Access Compliance Report Public Rights-of-Way (Curb Ramps)

Main Street: CLYDESDALE_DR Cross Street: ST_BRIDE_WAY Location: W

ADA ID: RPRK211110132723 Ramp Type: Type 4 - Parallel Initial Pass/Fail: Fail Overall Compliance: No Severity Score: 16

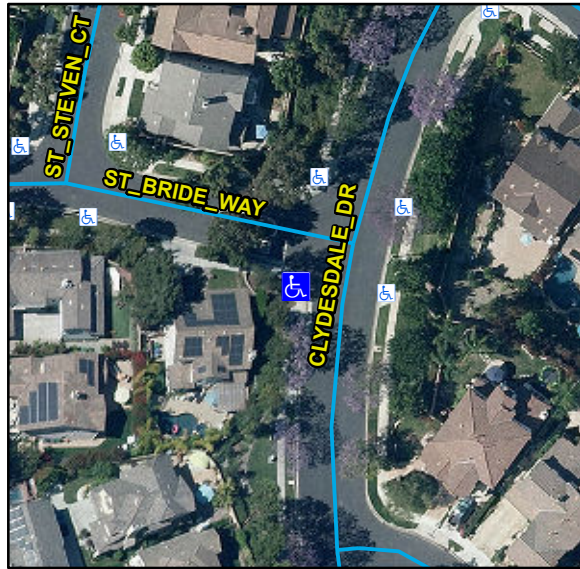
Compliance	Description	Data	Compliance	Description	Data
N/A	Ramp Length LT (in)	135	N/A	Ramp Length RT (in)	140
Yes	Ramp Width LT (in)	53	Yes	Ramp Width RT (in)	53
No	Ramp Run Slope LT (%)	8.8	Yes	Ramp Run Slope RT (%)	3.6
Yes	Ramp Cross Slope LT (%)	1.3	No	Ramp Cross Slope RT (%)	2.6
N/A	Landing Present	N/A	N/A	DWS Provided	N/A
N/A	Landing Length (in)	N/A	N/A	DWS Contrast	N/A
N/A	Landing Width (in)	N/A	N/A	DWS Length (in)	N/A
N/A	Landing Run Slope (%)	N/A	N/A	DWS Full Width	N/A
N/A	Landing Cross Slope (%)	N/A		DWS Offset Type	N/A
N/A	Landing Movement Obstructed?	N/A	N/A	DWS Offset Left (in)	N/A
	Landing Movement Type	N/A	N/A	DWS Offset Right (in)	N/A
N/A	Landing Shared	N/A			
N/A	Clear Space	Yes			
N/A	Clear Space To Crosswalk (in)	N/A			
N/A	Marked Crosswalk 1	No	N/A	Marked Crosswalk 2	No
	Crossing 1 Direction	SE		Crossing 2 Direction	NE
	Marked Crosswalk 1 Width (in)	N/A		Marked Crosswalk 2 Width (in)	N/A

Remove & Replace Curb Ramp With Two New Directional Ramps or Equivalent.
